Staff Report to the Planning Commission

January 7, 2026

Grandview One Family Detached Condominiums

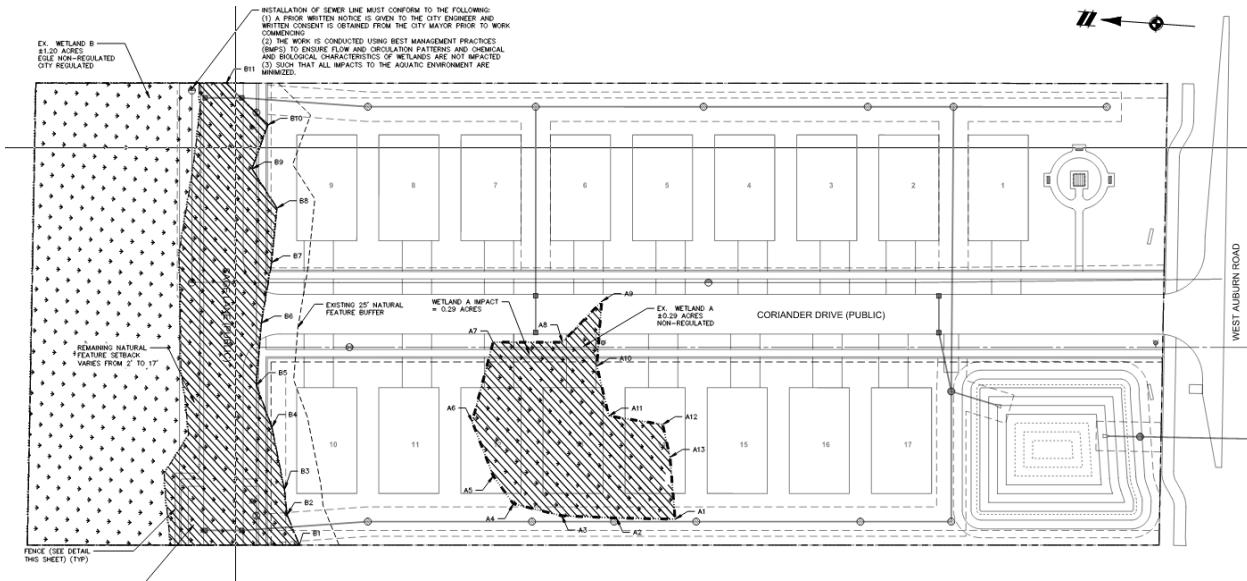
The City's wetland consultant, ASTI, verified the wetland boundaries onsite on August 21, 2025. One City regulated wetland was found in the northern portion of the site. A second wetland was identified more central to the site (due to its isolation, size of less than 1 acre, and low quality, it was determined that City regulations would not be applicable).

The City regulated wetland located onsite is a young forested wetland and is approximately 1.2 acres in size. The tree species of the forested wetland were largely native species consisting of Green Ash, Silver Maple, and American Elm (nonnative species were essentially nonexistent). The tree canopy of this area was approximately 70%.

The soils within the wetland area were comprised of Sandy Loams and in a natural state. In ASTI's opinion, the wetland area, while not always wet, appears to collect small amounts of seasonal water runoff or from precipitation. There does not appear to be any flood storage function.

Based on ASTI's assessment, the regulated wetland onsite is of a medium ecological quality and function and should be considered to be a medium value overall natural resource.

The site plan proposes approximately 0.42 acres of wetland impact (18,267 square feet). The impacts are a result of the construction of Sage Lane and it was determined between ASTI and City staff that the planned extension of Sage Lane was a public good and therefore could be seen as a larger benefit than complete preservation of the wetland in this particular area of the City and within the current context it exists.

The applicant is proposing to construct a 4'-6" fence along the north side of Sage Lane to help delineate the edge of the wetland. Typically, a boulder wall is utilized in this scenario, however, based on the location of the roadway, the utilities and the edge of the wetland as proposed, a fence may be the better option due to limited space and topography.
